NEW
RIVER

Burgess Hill

Design & Access Addendum

Proposed Section 73 Amendments

Proposed Chuch Walk Elevation

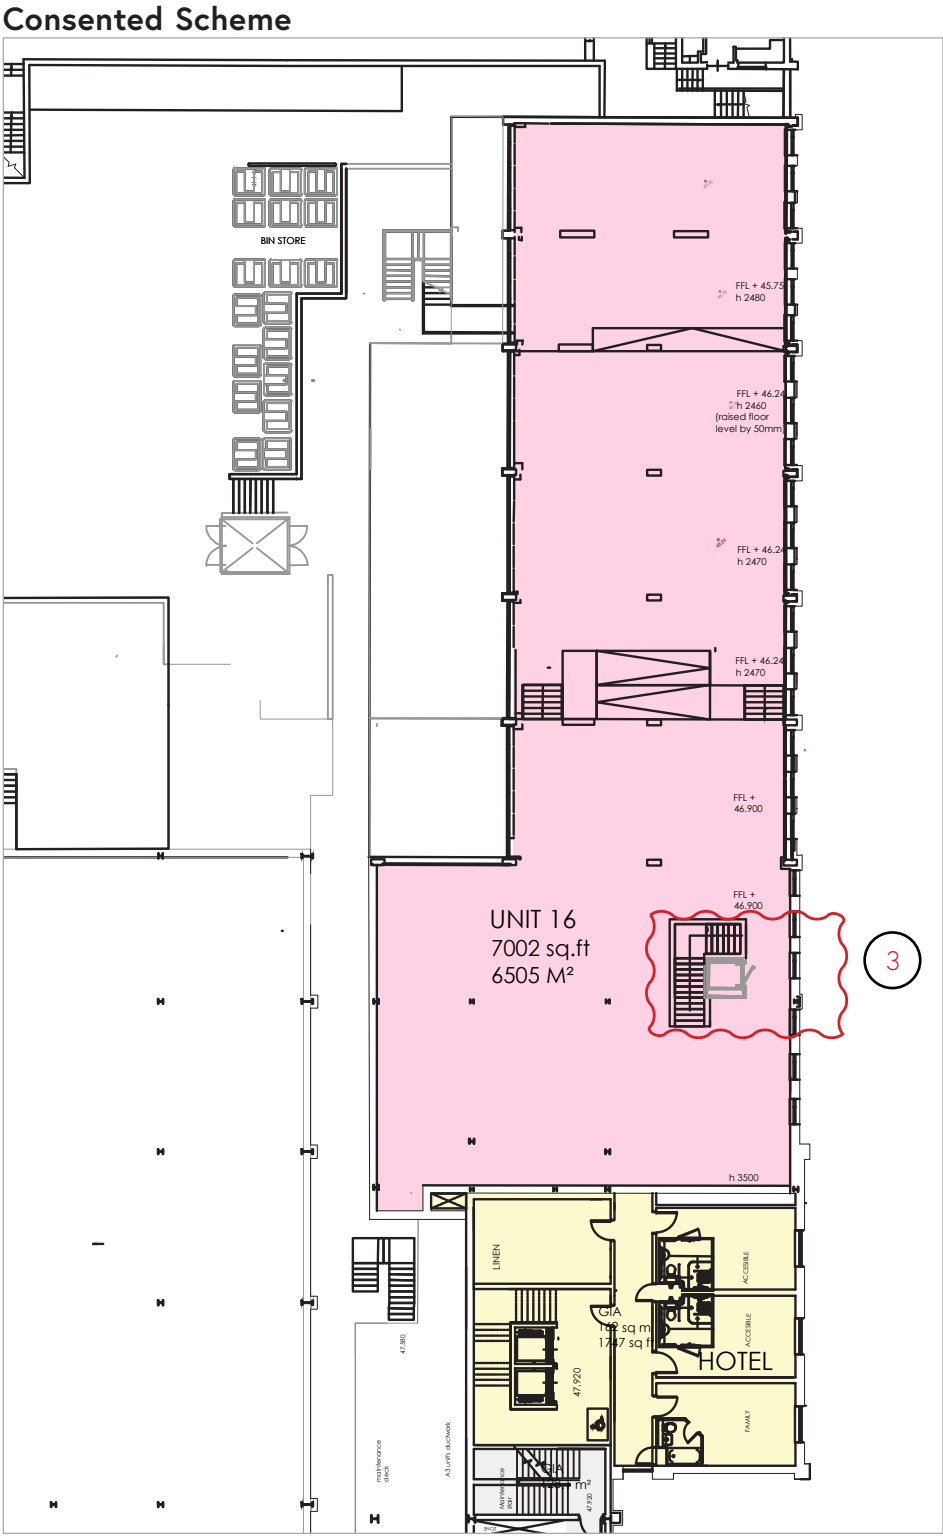
- 1. In the consented scheme retail Unit 8 amalgamated the existing units on Church Walk for use as a Gym. In this revised proposal the gym is relocated to the central Leisure Block facility (Block B) and the retail units are retained in their existing form as a series of small retail units on the high street of Church Walk.

- 2. Internally the adjustments that were previously consented to allow gym to occupy this space, including opening up of separating walls and ramping between varying floor levels, are no longer required. Instead the existing retail units will be stripped back, shell and core fit out completed and leased to tenants for full Cat B fit out.

- 3. The proposed new shop front at ground floor level will remain relatively unchanged to the consented application. However, with the above proposed strategy for separate retail units, each bay requires sliding entrance doors, whereas the consented application had fixed glazing to the central bays.

Proposed First Floor Plan - Level 02

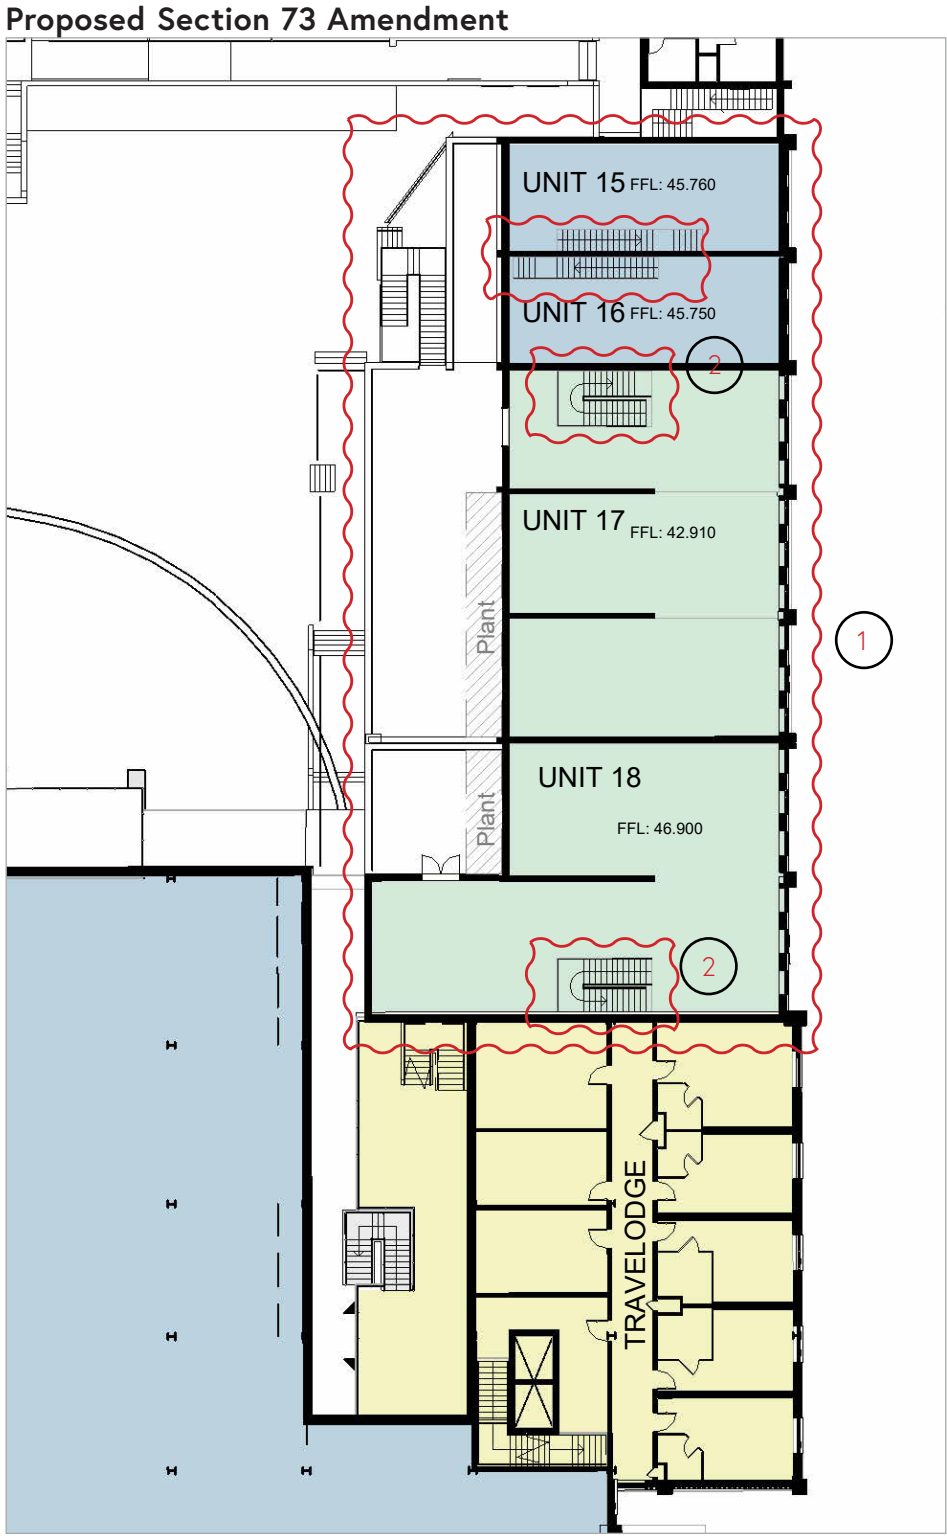
- 1. The consented scheme included an Office space - Unit 16 which was located at first floor level on Church Walk over the retail units 9/10/11/12. The consented office was open plan which required the existing buildings to be amalgamated by way of extensive structural work. The office spanned over varying existing floor levels which required ramped and stair connections. In the revised proposal the first floor office space is omitted. The existing first floor spaces are combined with the retail spaces below to provide 2 storey units for Units 15, 16, 17 and 18.
- 2. To facilitate the 2 storey retail spaces new staircases will be provided to each unit to give suitable public access to the first floor level.
- 3. The dedicated entrance to Unit 16, between the Hotel and Unit 12, will now be omitted and absorbed into the retail unit which is now labelled as Unit 18.

Proposed Section 73 Amendment
Proposed 3D Model Blocks A1/A2/B

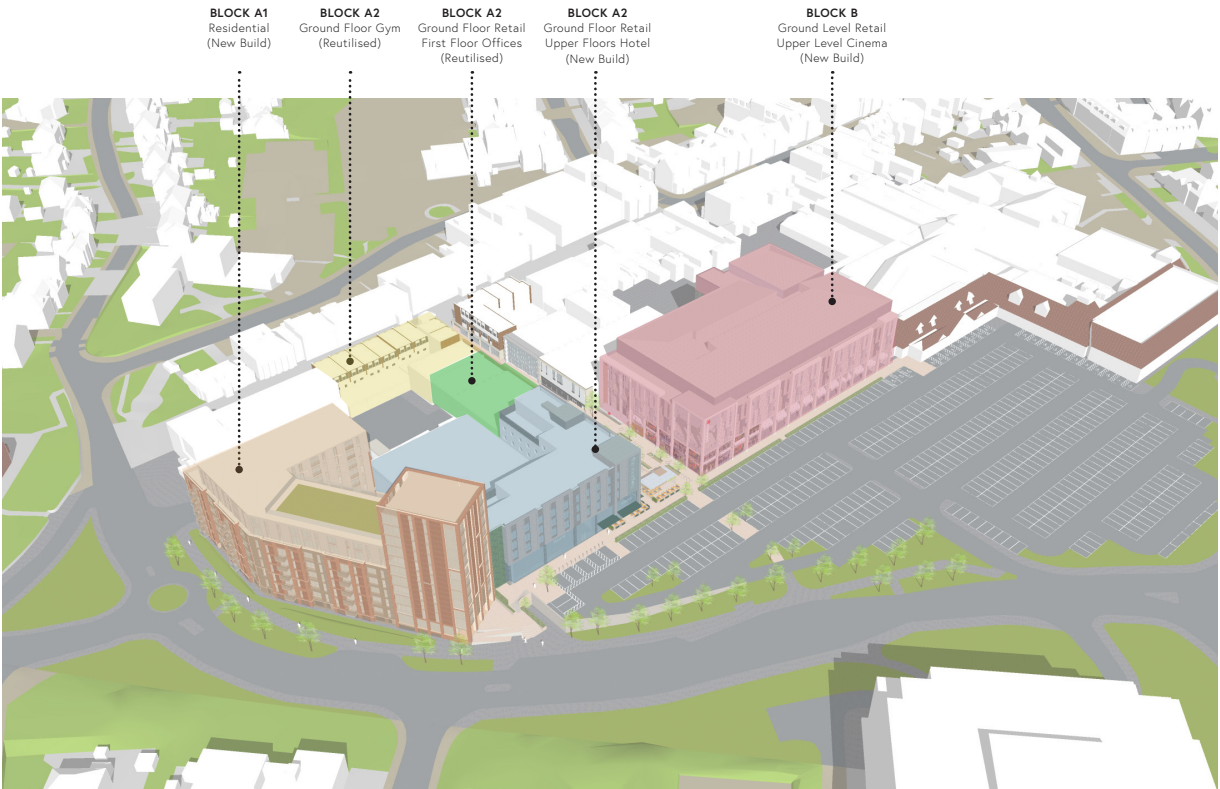
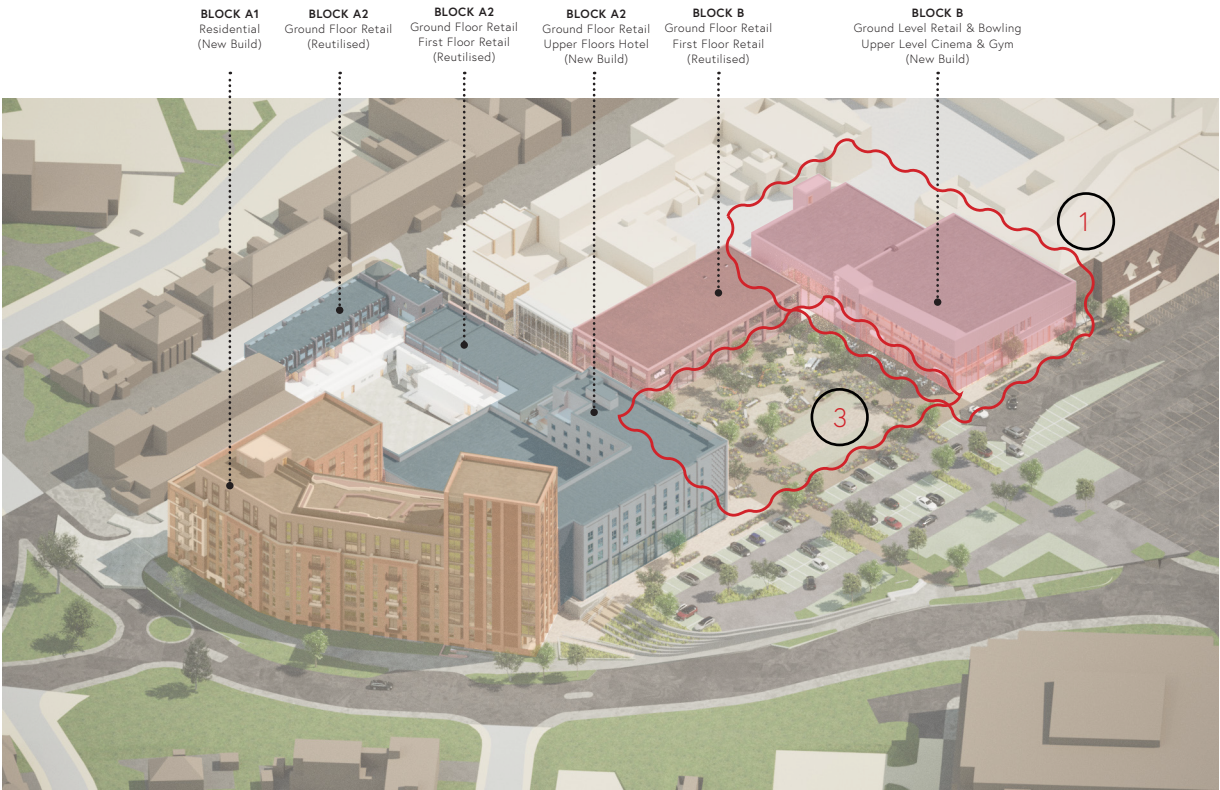
- 1. Previously consented Block B included a 10-screen multiplex cinema. This scale of cinema offering is too large in the current market. The proposed building massing has been reduced to provide a more market appropriate offering including a Boutique Cinema and retail units.
- 2. The North Western half of the building footprint has been removed, reducing the proposed footprint to approximately half of the consented scheme. The footprint of previously consented retail units 18/19 and part of 20 are omitted from the revised proposal.
- 3. The reduced building footprint has facilitated improvements to the public realm as detailed under the following section.

Proposed Ground Floor Plan - Level 01

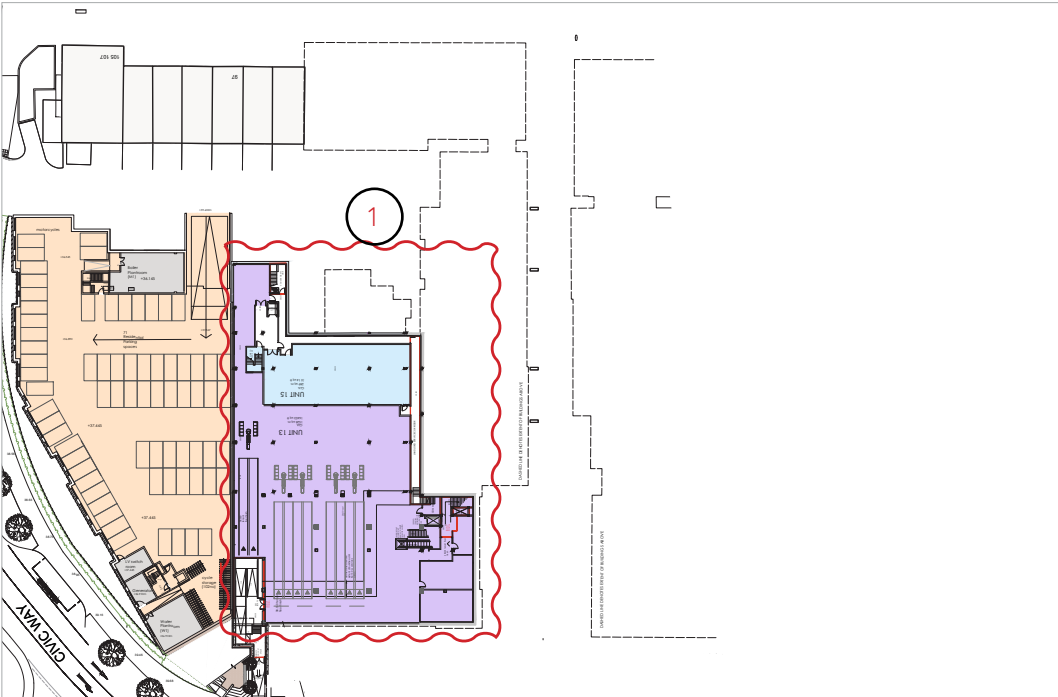
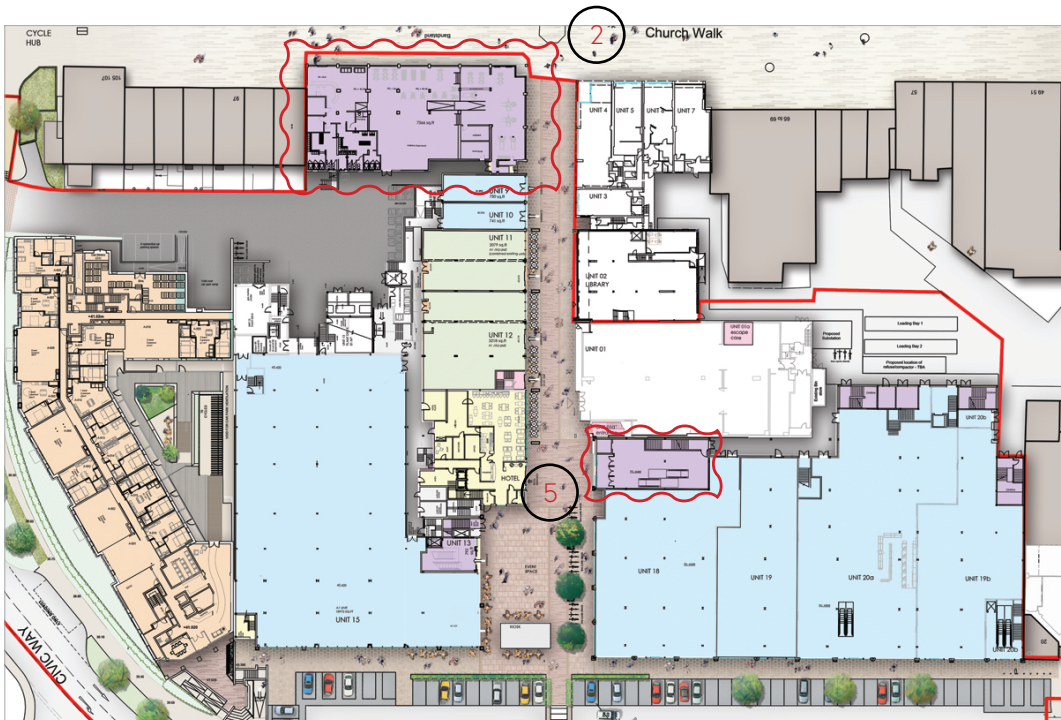
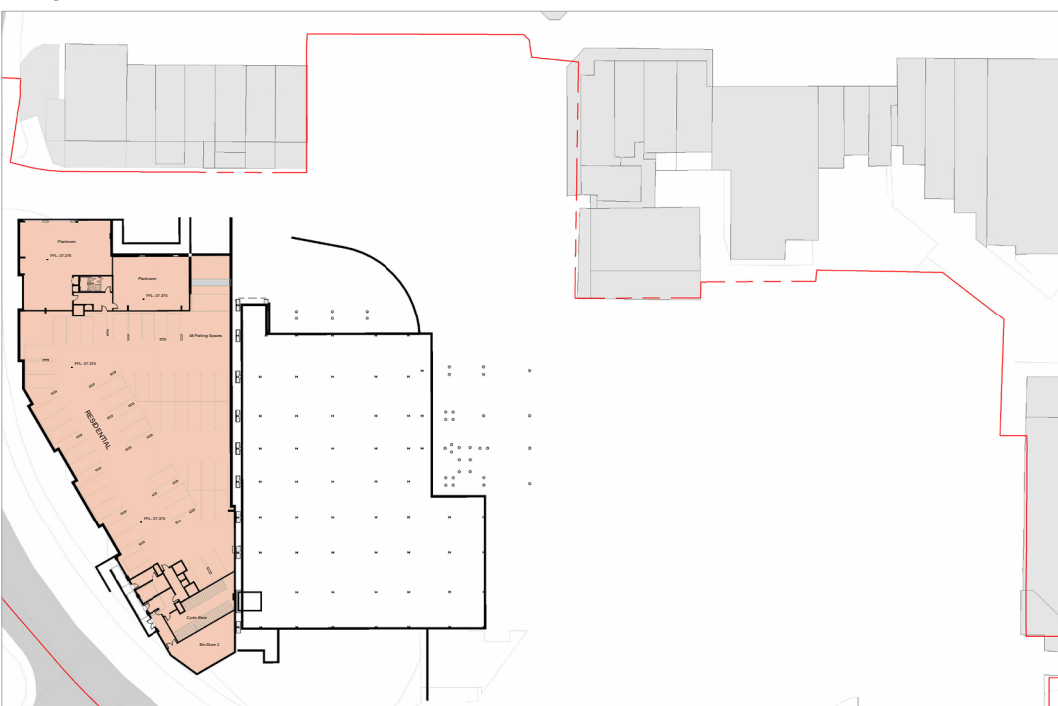
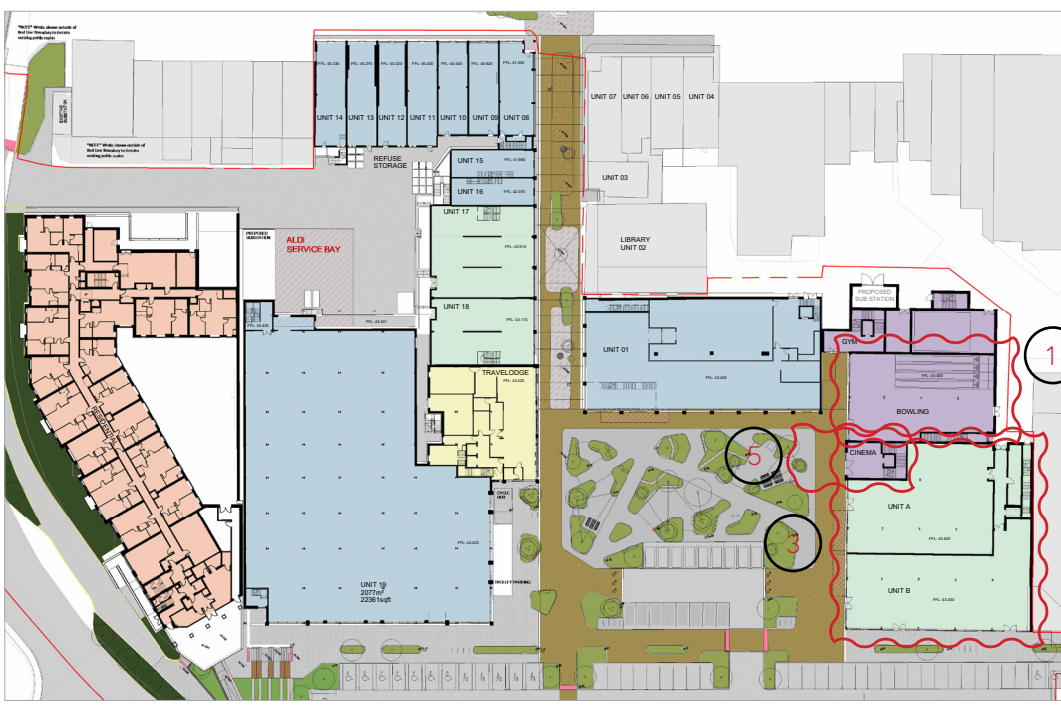
- 1. The previous Bowling Alley (Unit 13) has been omitted from the basement of Block A2 and relocated within the Leisure Building - Block B. The bowling alley will be positioned at ground floor level of the Leisure Building, accessed from the public realm of the new common space.

- 2. In the consented scheme the existing retail units fronting onto Church Walk were amalgamated into Unit 8 which was proposed as a Gym. The Gym has been relocated in the Leisure Building - Block B where it is now situated on the first floor level. The Gym has a separate dedicated stairwell with its entrance at ground floor level directly from the public realm of the new common space.

- 3. Retail provision retained but reduced in overall footprint in line with revised massing. The 3 retail units previously consented are replaced with 2 Retail units provided at ground floor level (Unit A&B) both with frontage onto the new public realm. Both units are intended for Food & Beverage uses.

- 4. Cinema provision retained within Block B. The previous scheme provided a 10 screen multiplex cinema. This has been reduced to a boutique cinema with 4 screens.

- 5. The cinema remains located over the retail provision at ground floor level. Due to the revised massing the cinema entrance is now positioned on the North Western Elevation with access from the public realm of the new common.

Proposed North West Elevation

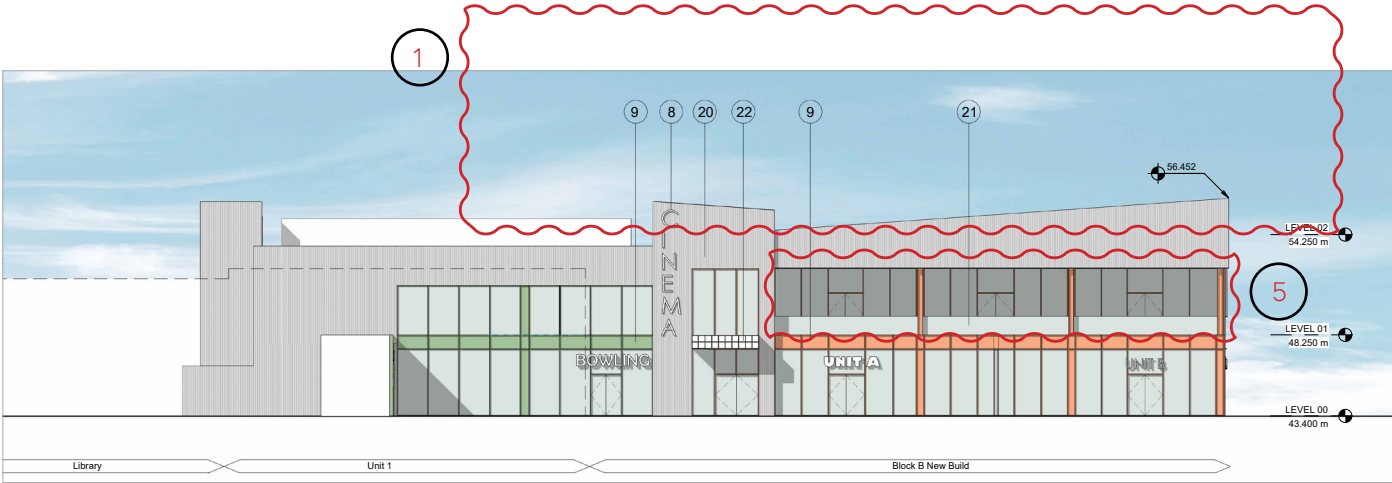
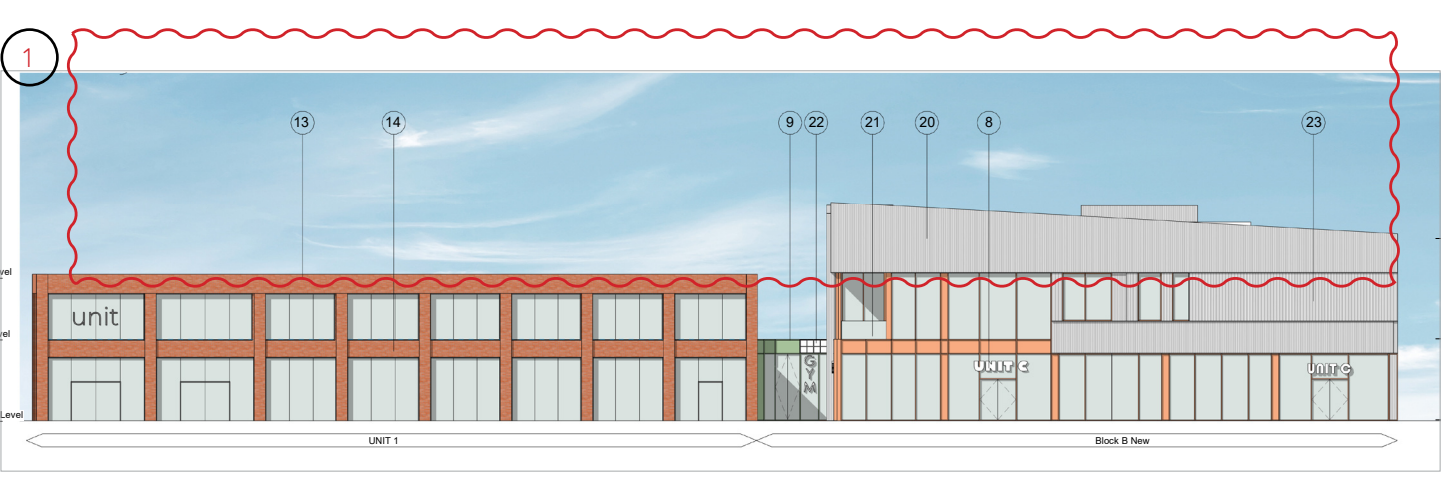
The new proposed cinema has smaller screen sizes reducing the need for large expanses of raked seating and associated ceiling clearance. The height of the building is reduced from 5-storeys to 2-storeys, accounting for a reduction in height from 23.5m to 13.0m from ground floor level. The new height sits more appropriately within the revised proposal and the adjacent existing shopping centre.
2.

The design of the building has changed, the revised proposal focused on the relationship of the proposal to its context, both existing and proposed as well as the viability of delivering leisure provision in the current market.
3.

The consented elevational treatment followed the principle of splitting the horizontal mass into a vertical elements with a series of bays similar to the language of Block A. The significant reduction in the proposed massing has allowed the elevational treatment to be reviewed; structure, glazing and entrance points are used to provide vertical division to the mass rather than bays. This has enabled the block to take on a language that contrasts and compliments the retail rather than copying it - which in turns allows the block to express its leisure use.
4.

The previous materiality uses stone effect cladding panels with a variety of patterns/textures as well as a grey stone effect cladding for the step back upper levels. The revised materiality balances silver corrugated metal panels with coloured aluminium glazing.
5.

Inclusion of a terrace within the cinema provision provides depth to the façade.
